Amendments to the Drawings:

REMARKS

FIG. 11A

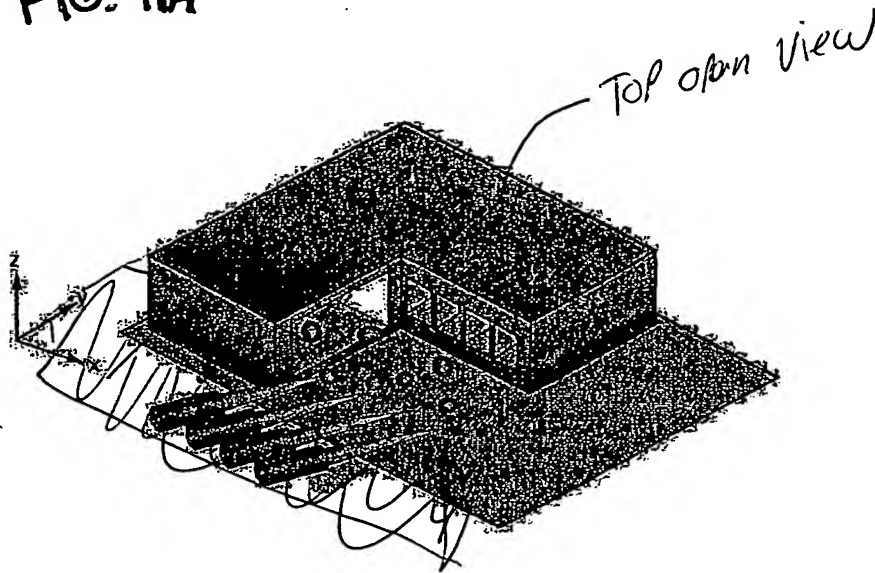
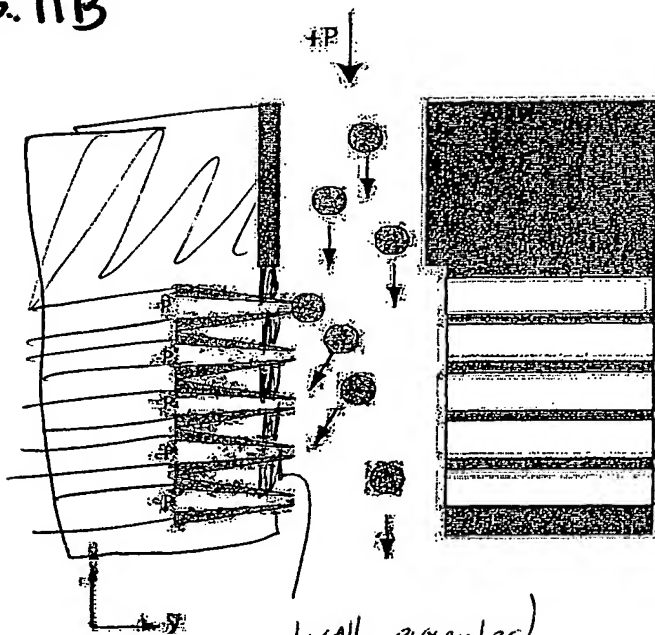
The Examiner has objected to the drawings. The Examiner argues that "all of the claimed structures encompassed by claims 1 – 8, 11 – 18, 21 – 30, 87 – 89, 93 – 95, 97 – 101 and 109 – 116 must be shown or the feature(s) canceled from the claim(s)." (Office Action, p.3).

The attached single sheet of drawings include changes to Figs. 11A and 11B:

As noted above claims 1-116 are cancelled. A corrected drawing showing the structures of the currently claimed invention is herein submitted. Specifically, the corrected drawing illustrates that the non-planar elements are an integral part of the microfluidic chip and have a surface defining the opening which comprises portions of a wall of a cell chamber.

WALL extended
Non planar element IS Integral part of chip
